SUBJ: **Addendum 1 – Clarifications to the Specifications and Responses to Vendor's Questions**

BID ITEM: **Bid Item #23-150 Construction - Airfield Electrical System Upgrade for Runways 5-23 & 11-29 for Augusta, GA – Daniel Field Airport**

ADDENDUM NO. 1

E1
 Sheet 25 of 52

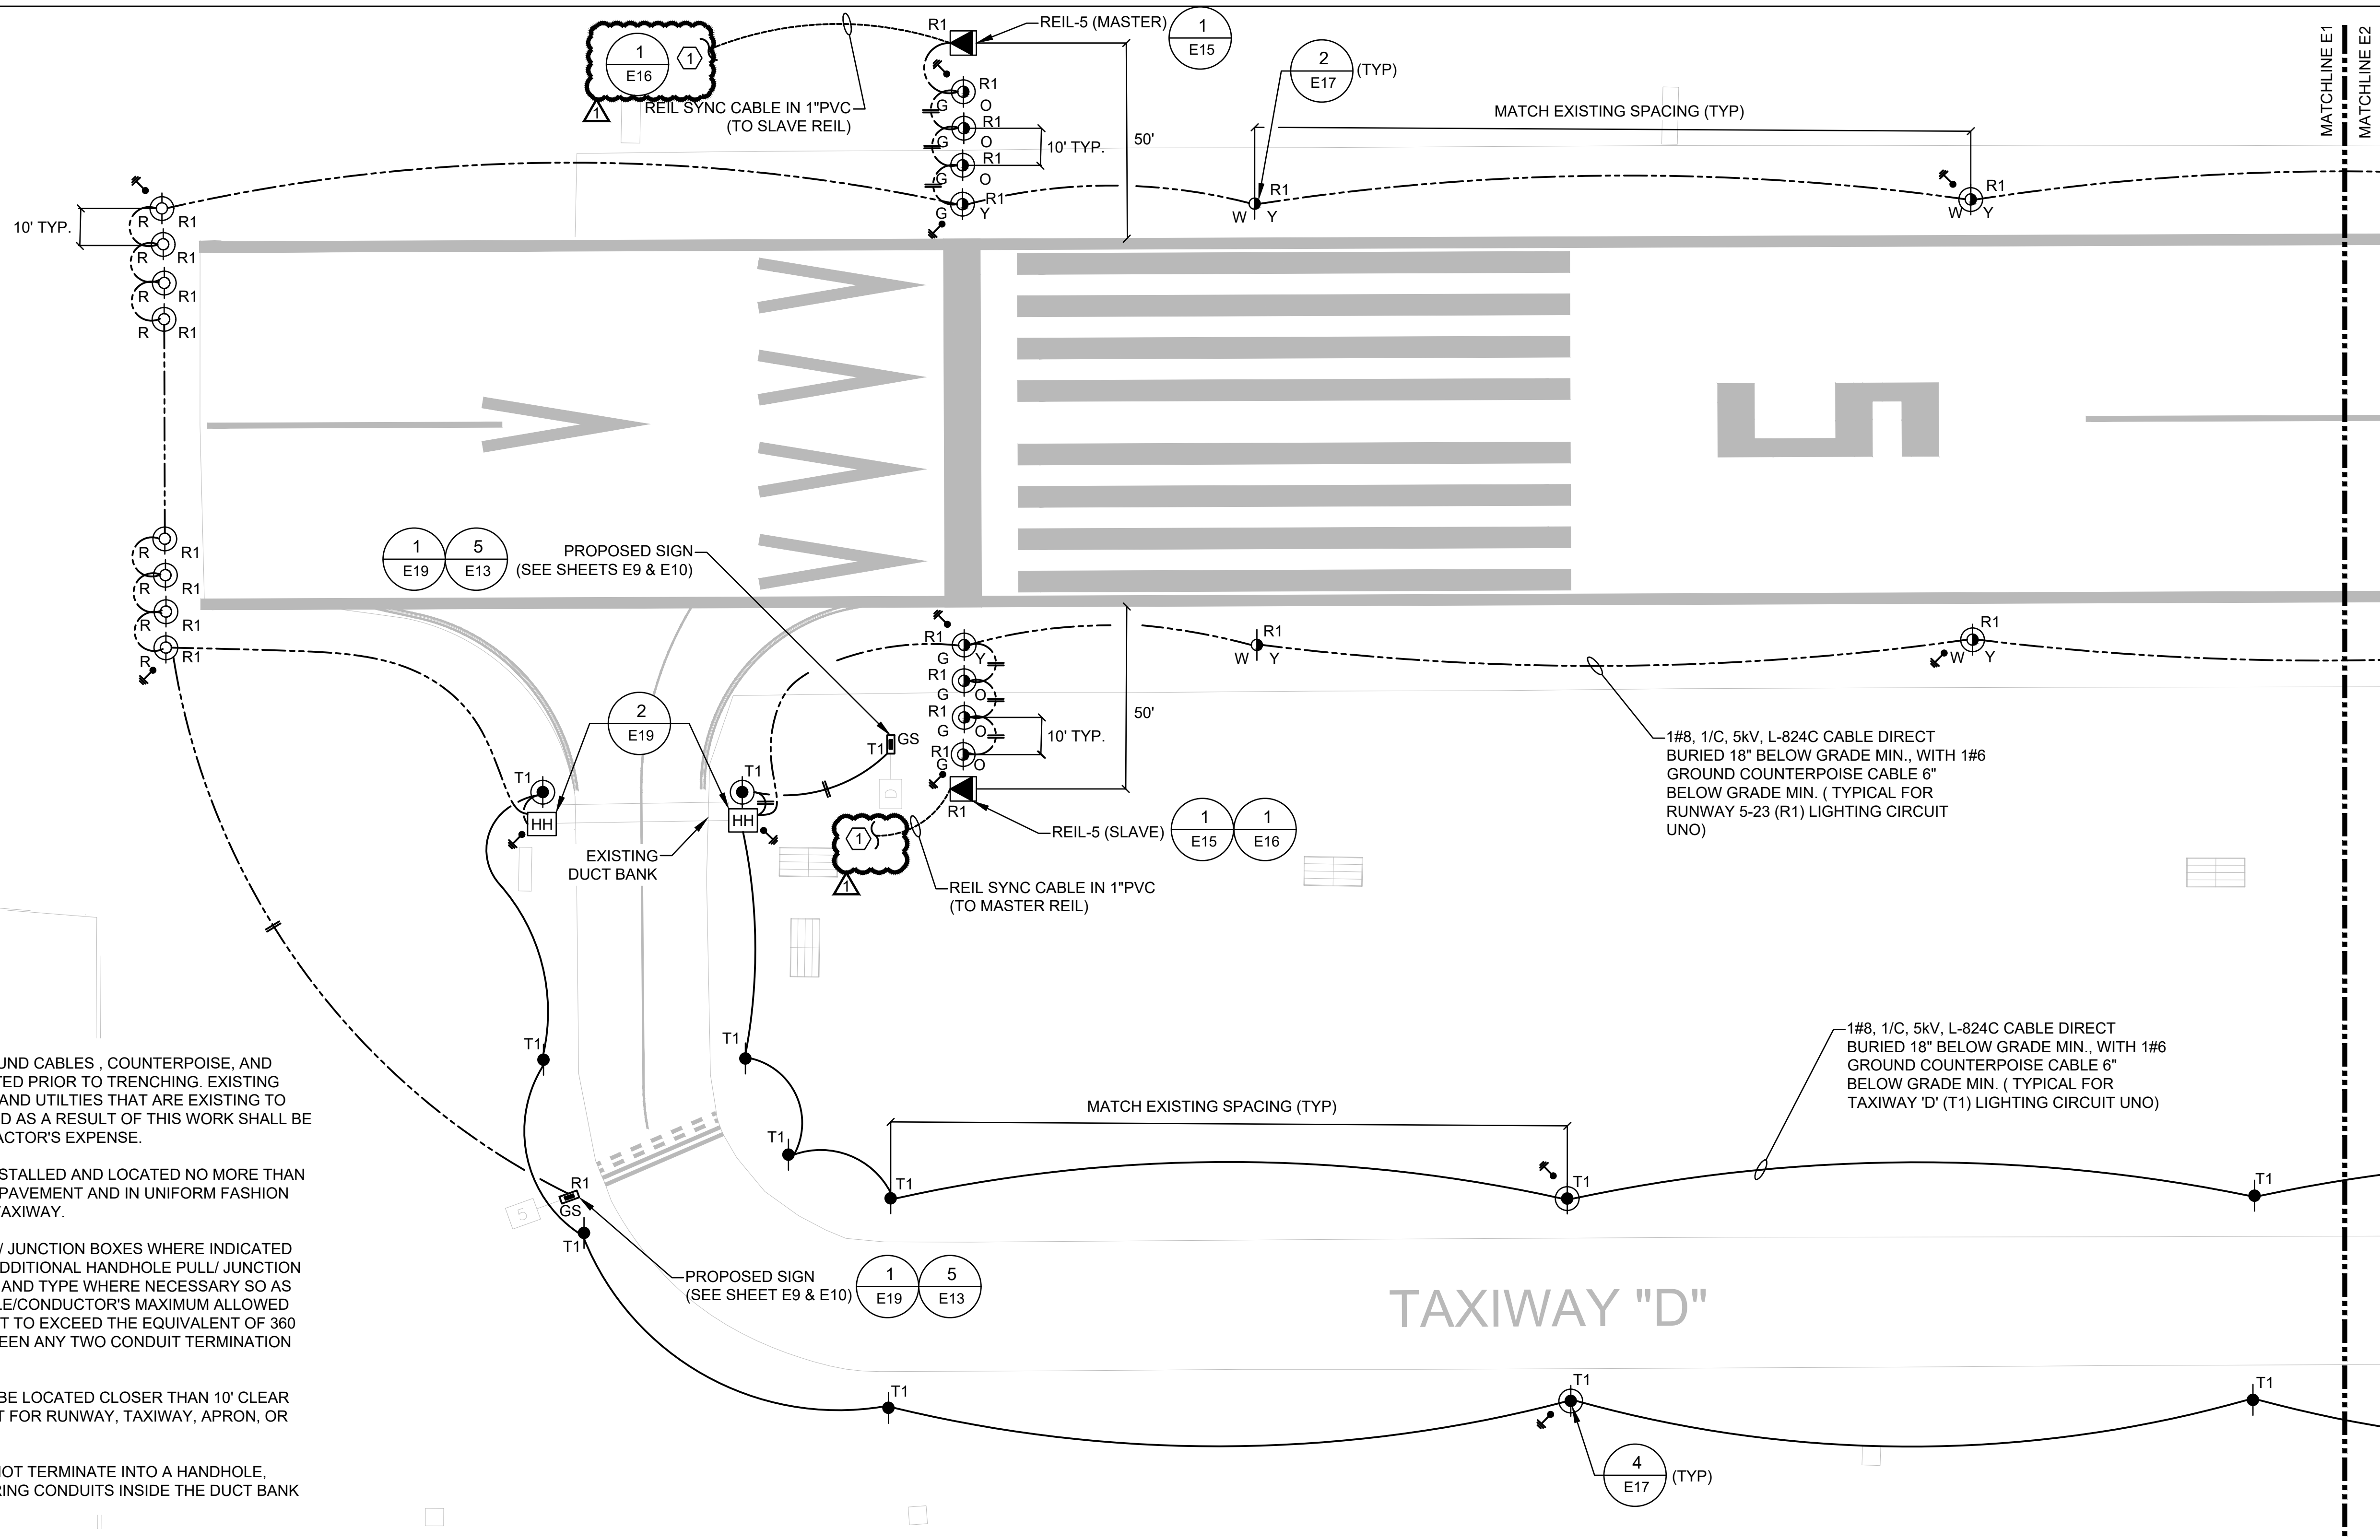
- L. **Replace Sheets E1 - E2** – Airfield Lighting & Wiring Plan – Runway 5/23 – Part 1-2 with revised Sheets E1 - E2 attached to this Addendum 1.
- Scale of this sheet revised from 1"=50' to 1"=25'.

- Deleted all Field Lightning Arrestors.
 - Deleted Keynote 1 associated with Field Lightning Arrestor.
 - Keynote 2 revised to Keynote 1.
- M. **Replace Sheet E3** – Airfield Lighting & Wiring Plan – Runway 5/23 – Part 3 with revised Sheet E3 attached to this Addendum 1.

E3

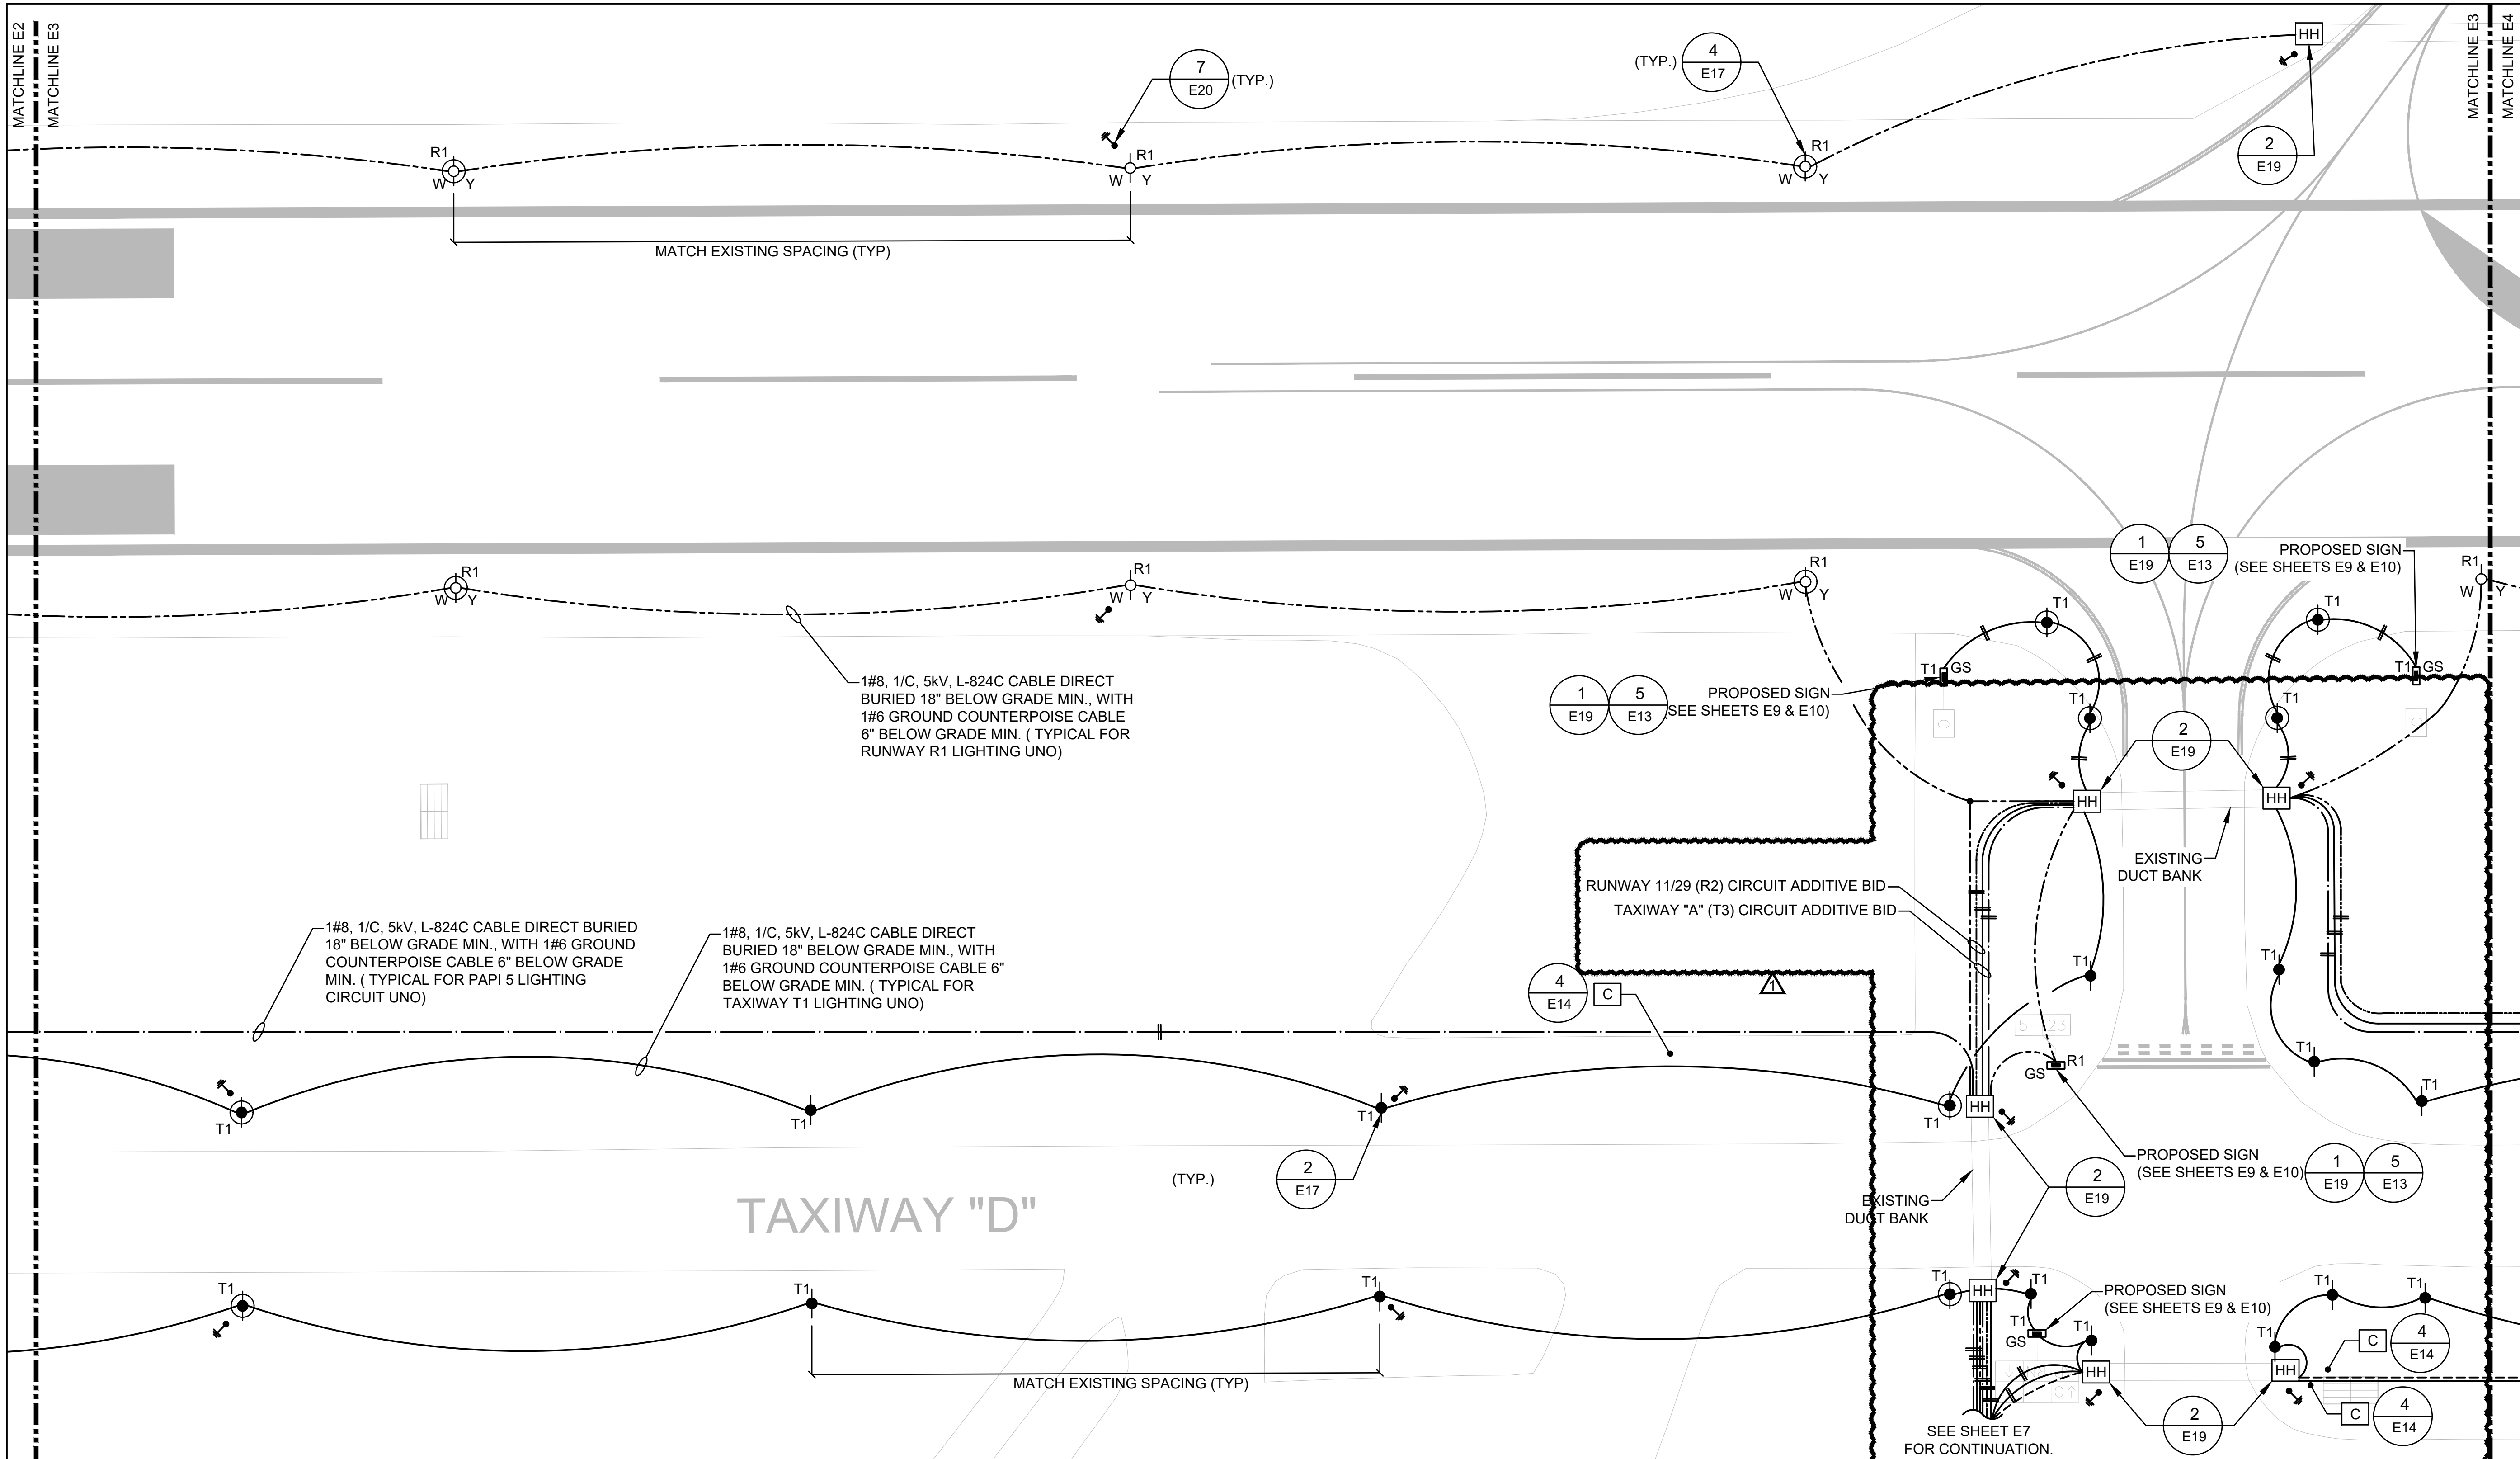
- Scale of this sheet revised from 1"=50' to 1"=25'.
 - Deleted all Field Lightning Arrestors.
 - Deleted Keynote 1 associated with Field Lightning Arrestor.

- Runway 11/29 (Additive Bid) & Taxiway A (Additive Bid) routing of wiring shown back to vault.
- N. **Replace Sheet E4** – Airfield Lighting & Wiring Plan – Runway 5/23 – Part 4 with revised Sheet E4 attached to this Addendum 1.

E4
 Sheet 28 of 52

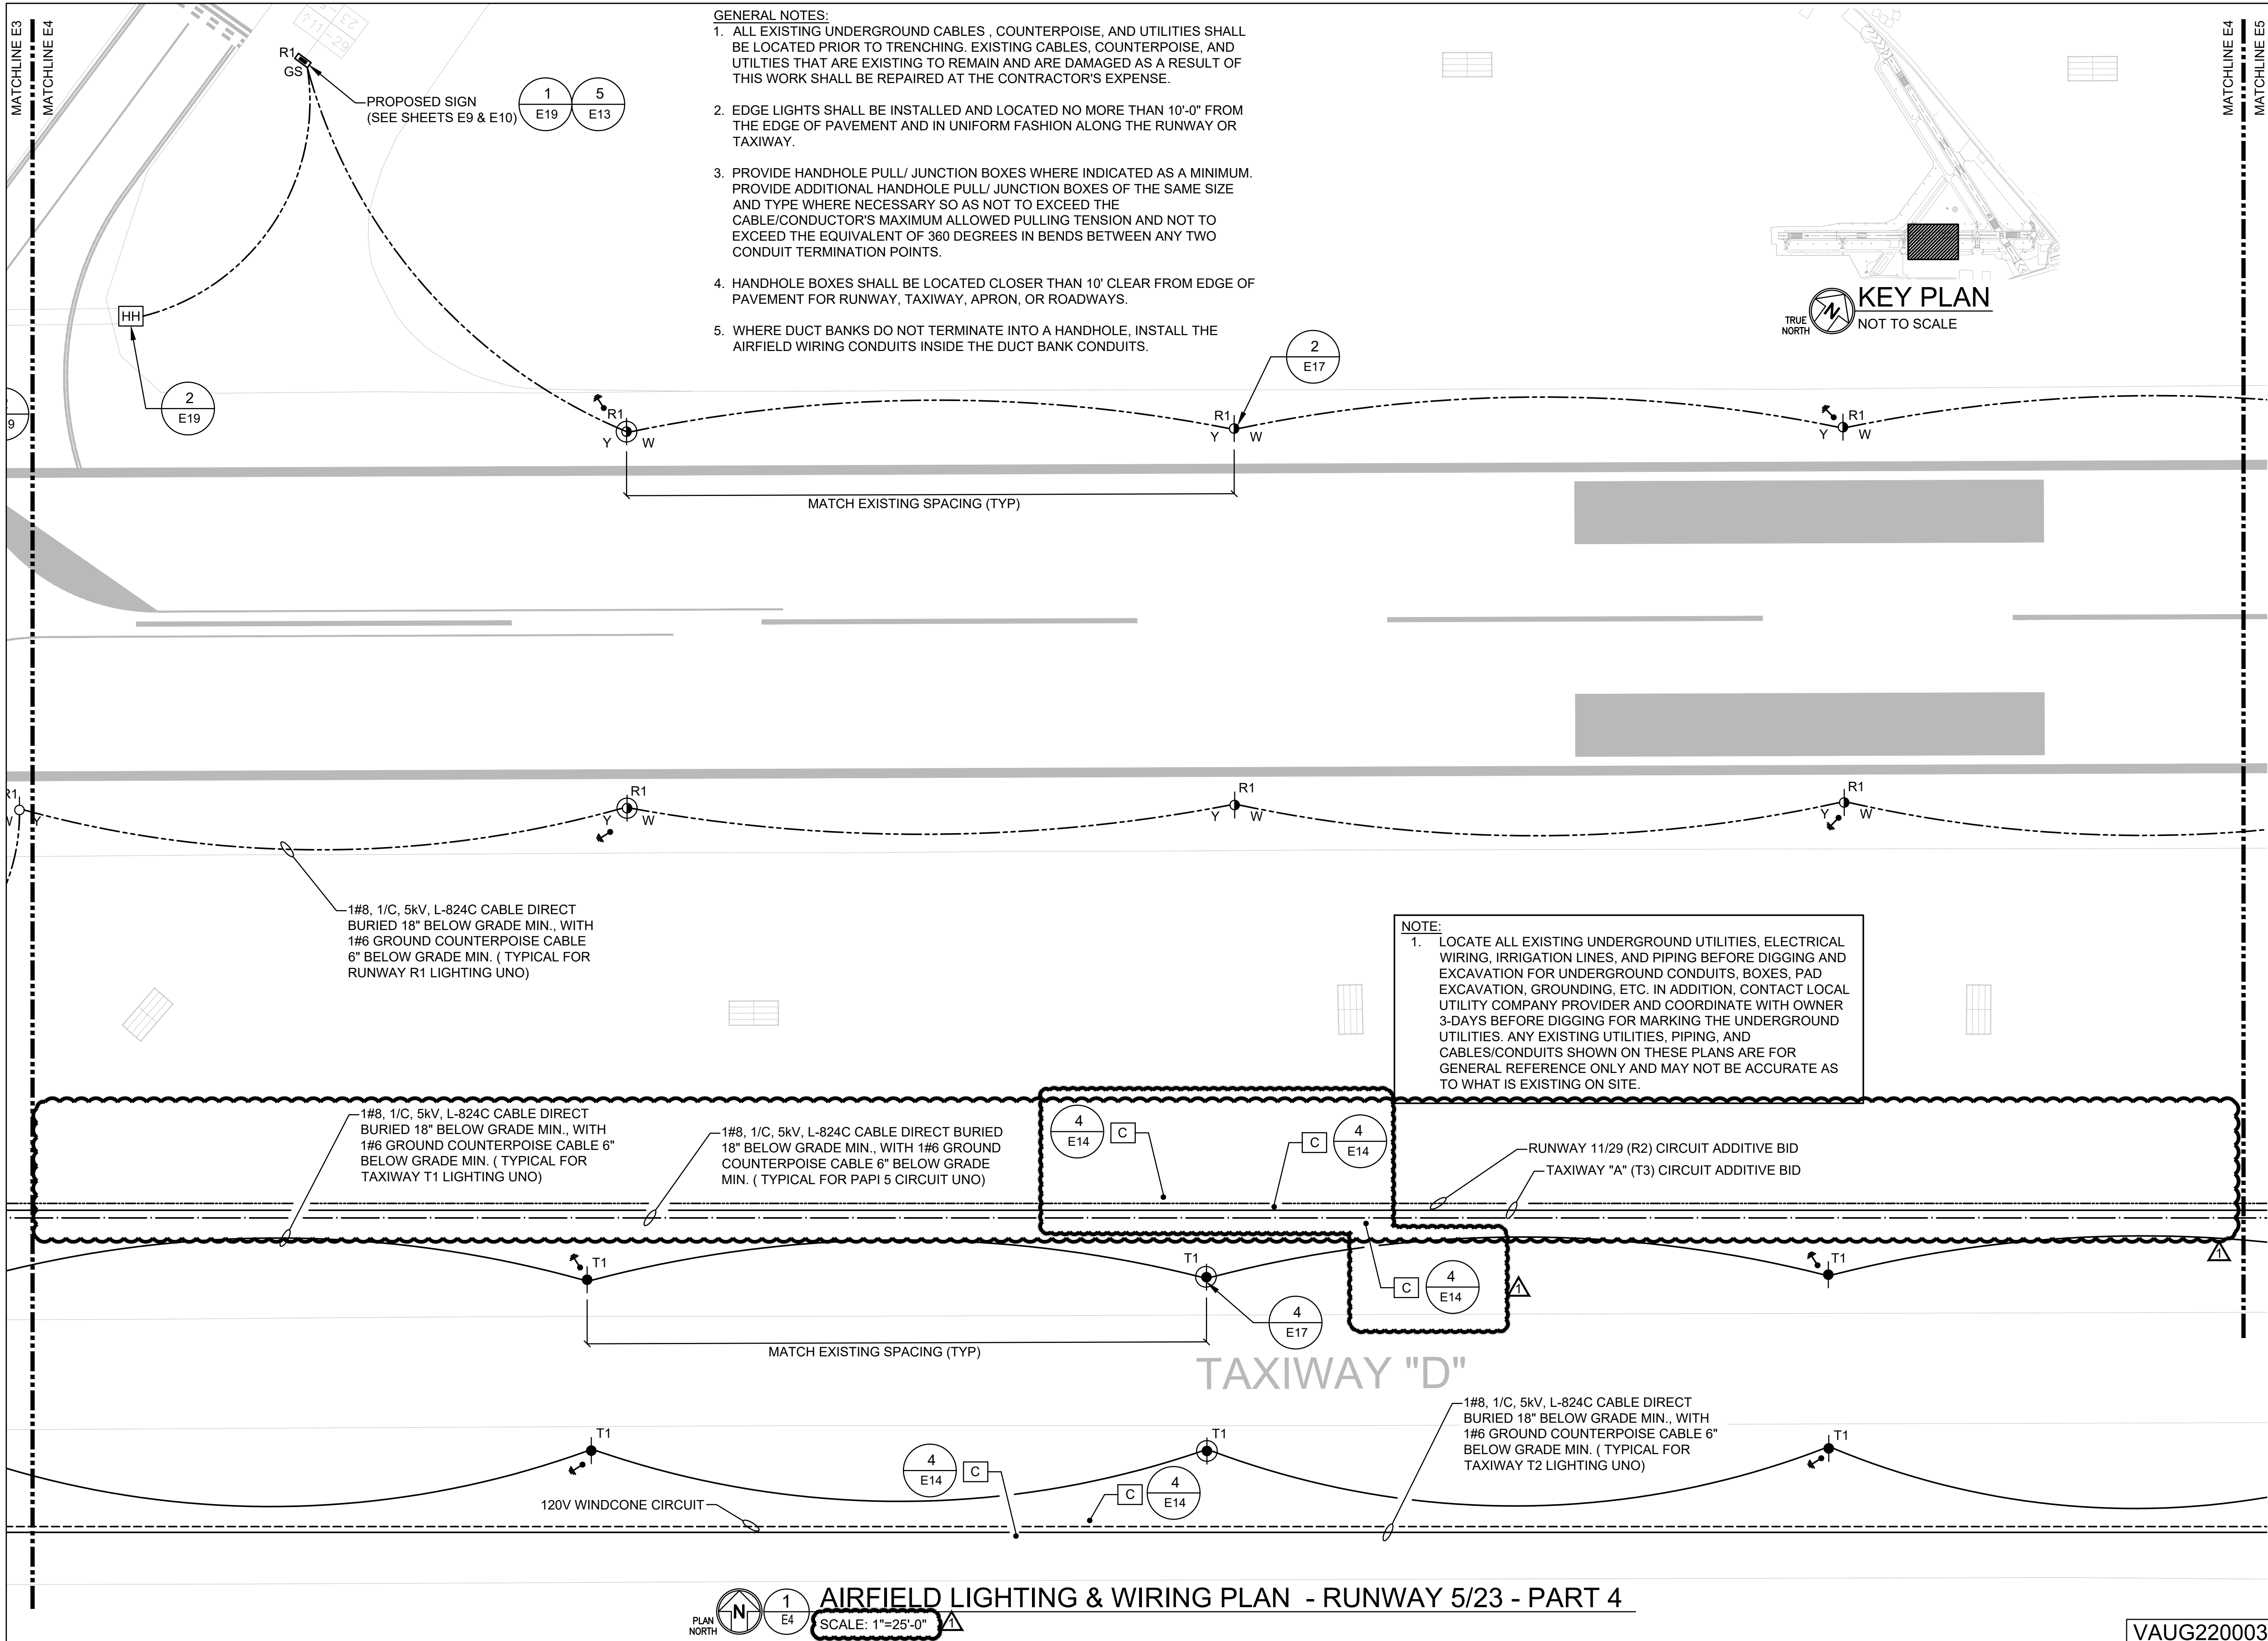
- Scale of this sheet revised from 1"=50' to 1"=25'.
 - Deleted all Field Lightning Arrestors.
 - Deleted Keynote 1 associated with Field Lightning Arrestor.

- Runway 11/29 (Additive Bid) & Taxiway A (Additive Bid) routing of wiring shown back to vault.
 - Added Conduit markers for Runway 11/29 & Taxiway A Circuits.
